Colorado Springs Utilities

**Subject: South Raw Water Pipeline 3 (S3) Construction Restoration, Southern Delivery System (SDS), 1041 Permit No. 2008-002**

**SUBJECT:** Responses to Total Terrain's Site Review of S-3 Revegetation and Erosion Control, Dated October 1, 2012

**Map Comparing Pre- and Post-Construction Ground Elevations for S3**

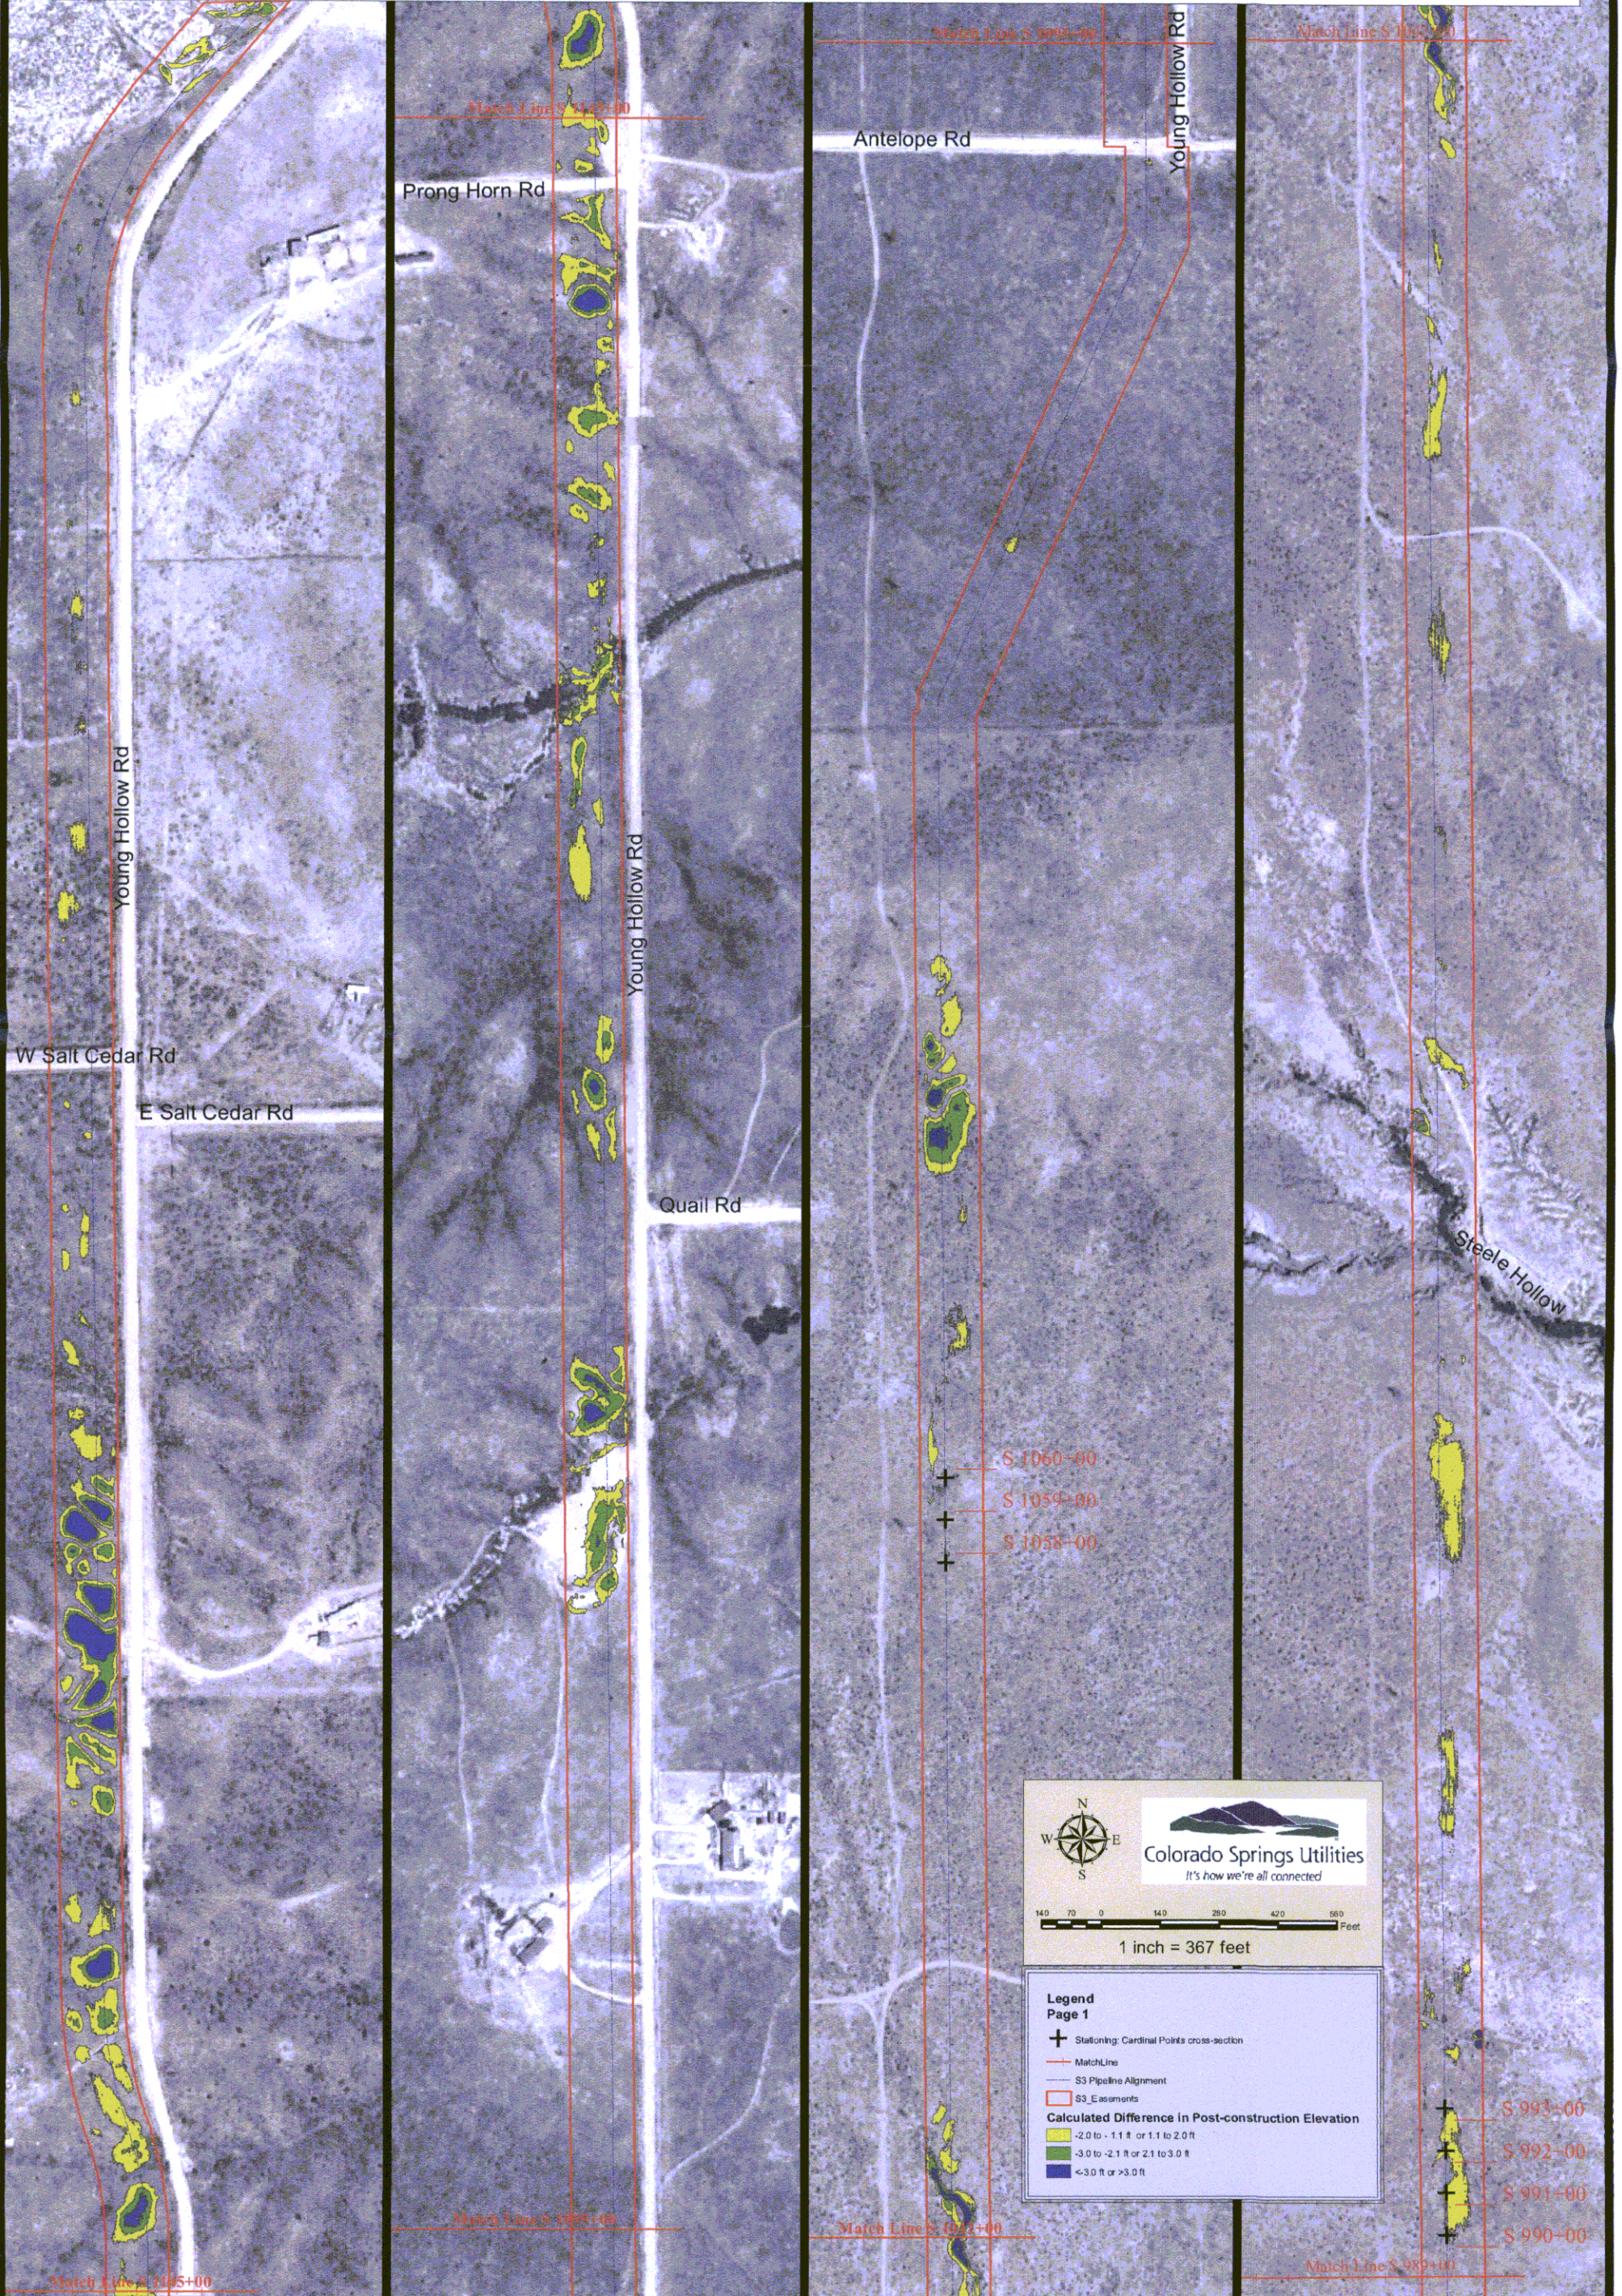
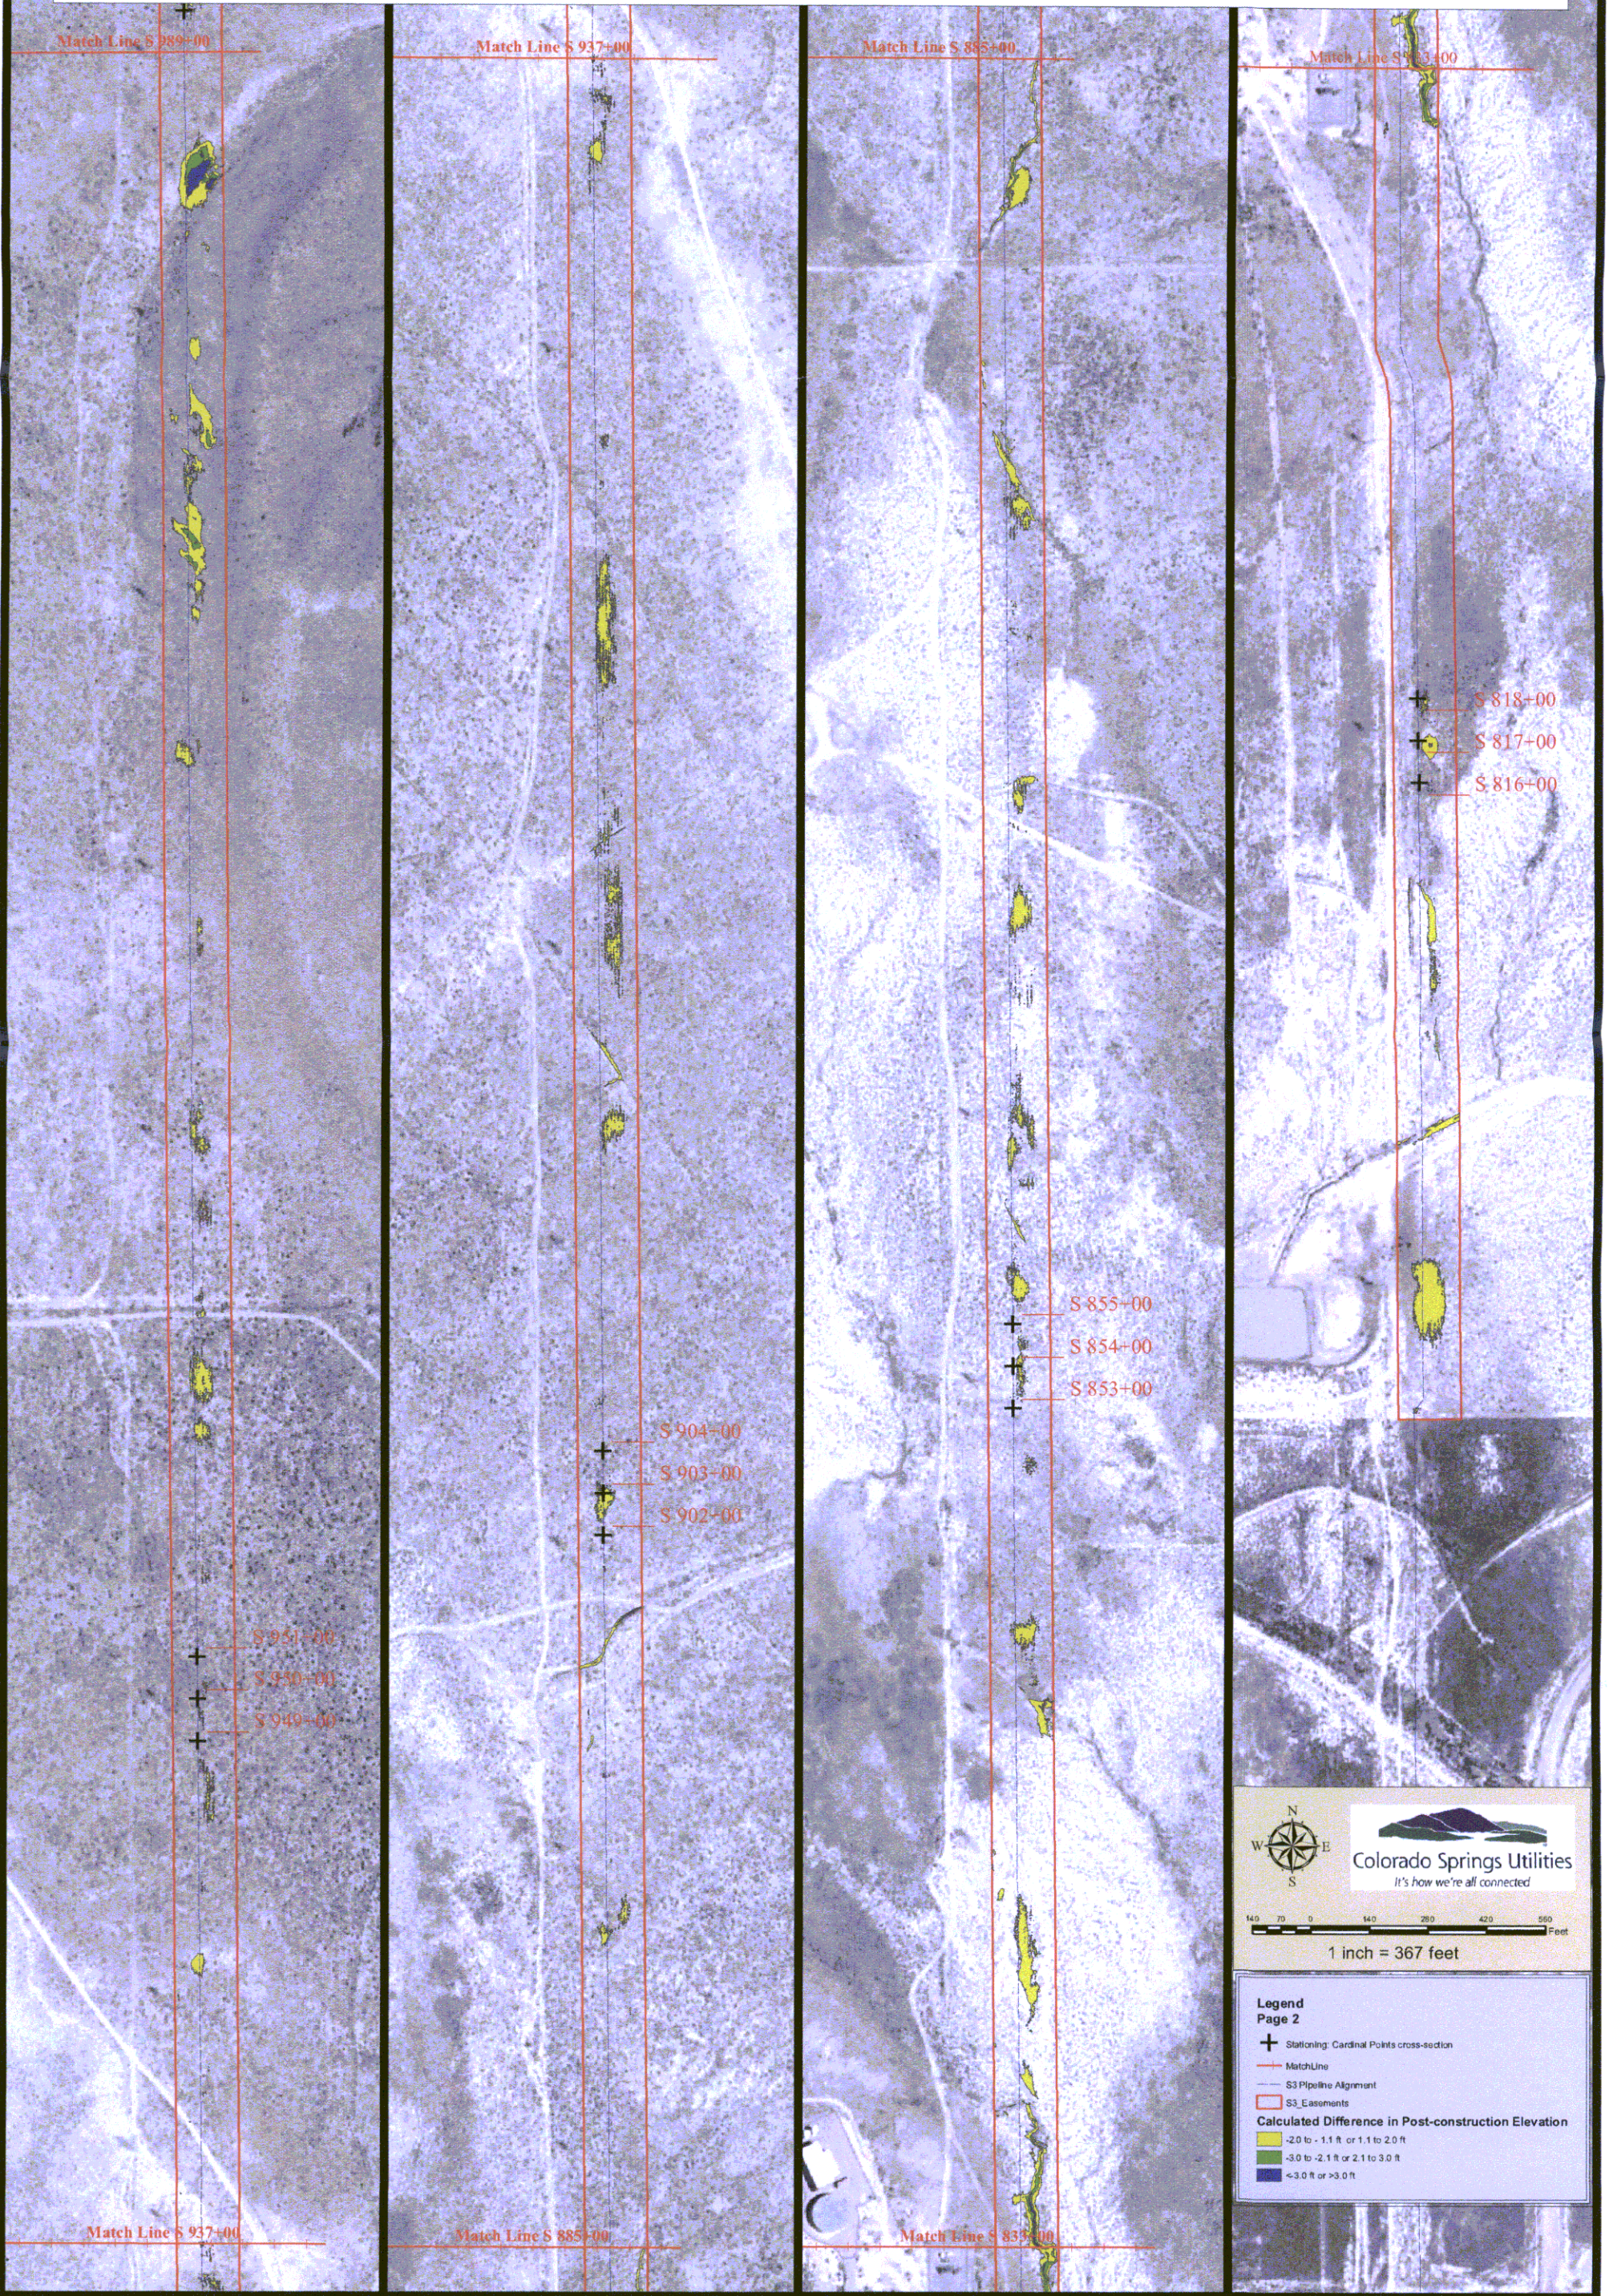
The construction area for S3 covered 140.8 acres, including the 3.2-acre crossing of Steele Hollow. The Steele Hollow crossing was constructed in accordance with a channel design permitted by the U.S. Army Corps of Engineers (Individual Permit No. SPA-2005-0013-SCO and Nationwide Permit 13) and was not intended to be restored to pre-construction contours. Of the remaining 137.6 acres affected by S3 construction, 126.1 acres (92 percent) have been regraded to within one-half foot of the pre-construction elevation and 133 acres (97 percent) have been regraded to within one foot of the pre-construction elevation (Table 1). Differences between one and two feet occur on approximately 3.1 acres (2 percent) and differences greater than two feet occur on 1.6 acres (1 percent). Locations with differences of two feet or greater are principally north of Walker Ranches and Antelope Road within undulating terrain. Absolute differences in pre- and post-construction elevations are depicted on a map in Attachment A.

The areas identified below represent the vast majority of the 4.7 acres with a post-construction elevation differing by more than one foot from pre-construction conditions.

Pre- and post-construction survey data coupled with interpretive information about S3 design and construction features indicate that the contours and drainage paths for disturbed areas have been reestablished in accordance with the Condition C-9(1) of the 1041 Permit (No. 2008-002). Nonetheless, Colorado Springs Utilities remains committed to working with landowners to address their preferences for post-construction restoration. Accordingly, and with Pueblo County's concurrence, we will offer to make some minor grade adjustments at locations selected with concerned landowners.
